Certificate of Appropriateness

2675 N. SUMMIT AV.

North Point North Historic District

PTS ID 104708 COA

House at 2675 North Summit Avenue

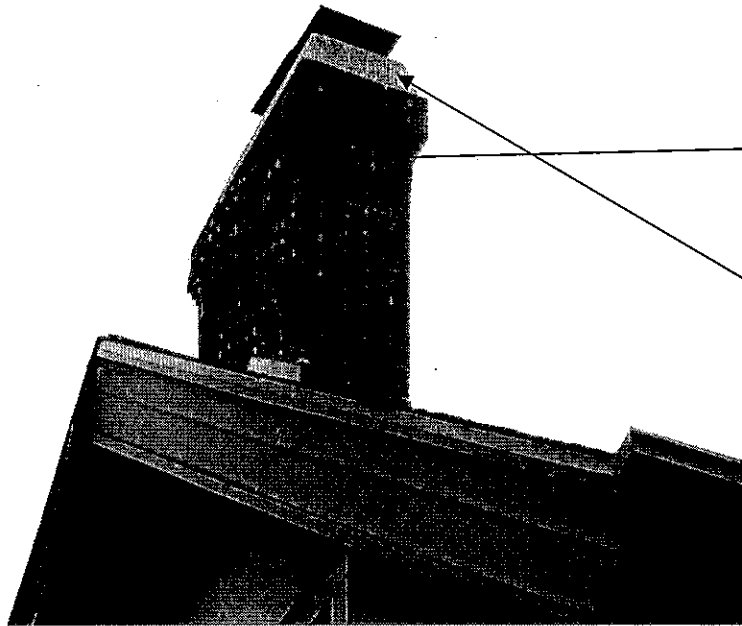
**New Marvin Alpine wood combination
storms/screens to be installed at these
locations.**

New membrane roofing will be applied over existing membrane roof at these locations

Chimney to be rebuilt to match original and will make use of reclaimed brick from the original as well as new matching brick if needed. Note the pattern near the top of the chimney just below the corbeling. New concrete cap will extend slightly beyond chimney to shed water.

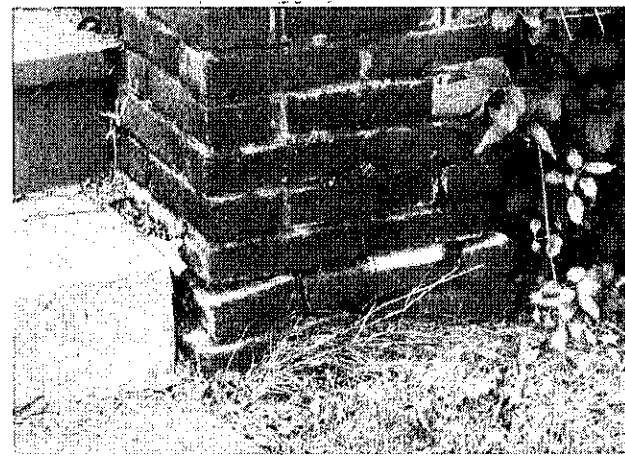
MASONRY REPAIR NEEDED

MASONRY REPAIR NEEDED

MASONRY REPAIR NEEDED

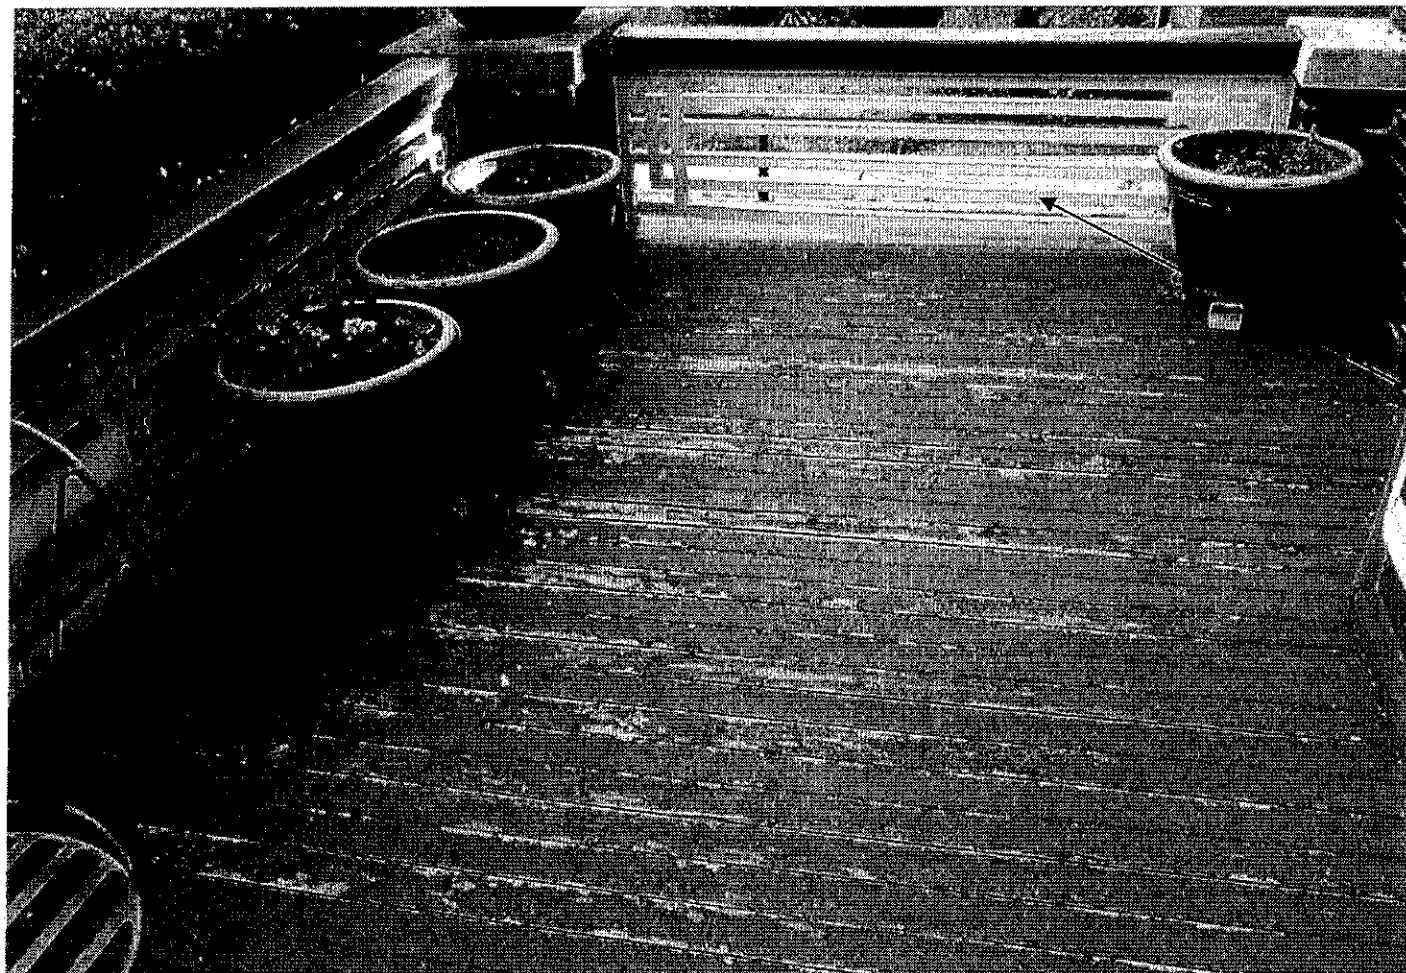
Masonry around the porch area will be repointed. Note sections that have been improperly repointed and where mortar has been carelessly applied. New mortar must match original in terms of hardness, color, composition and texture. Using too hard of a mortar will result in brick failure.

**Porch
railing
will
remain**

Porch deck will be replaced with Douglas Fir tongue and groove boards.

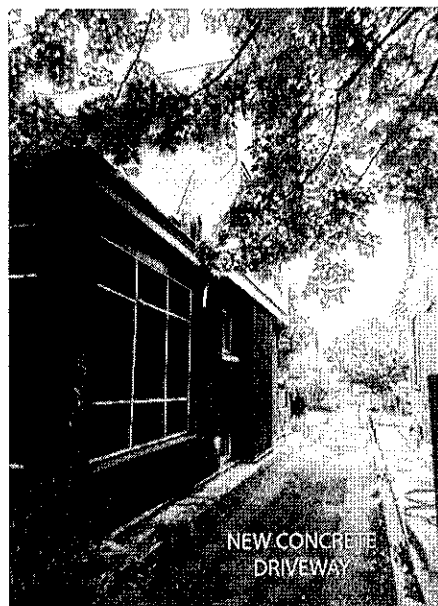
Retain 
curbing along
north end of
driveway

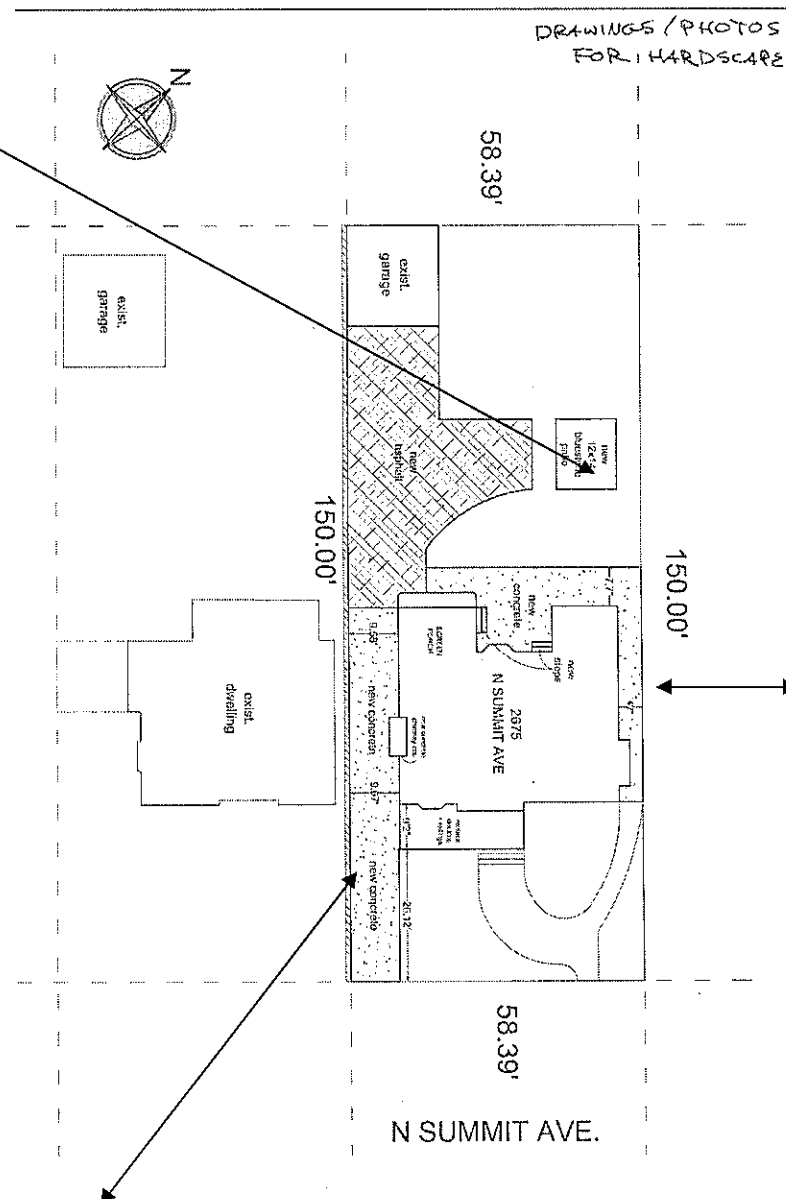
**New patio
will be of
Blue stone
or Turfstone**

A new concrete driveway will be poured as well as apron in front of garage, and north and west walkway and rear steps.
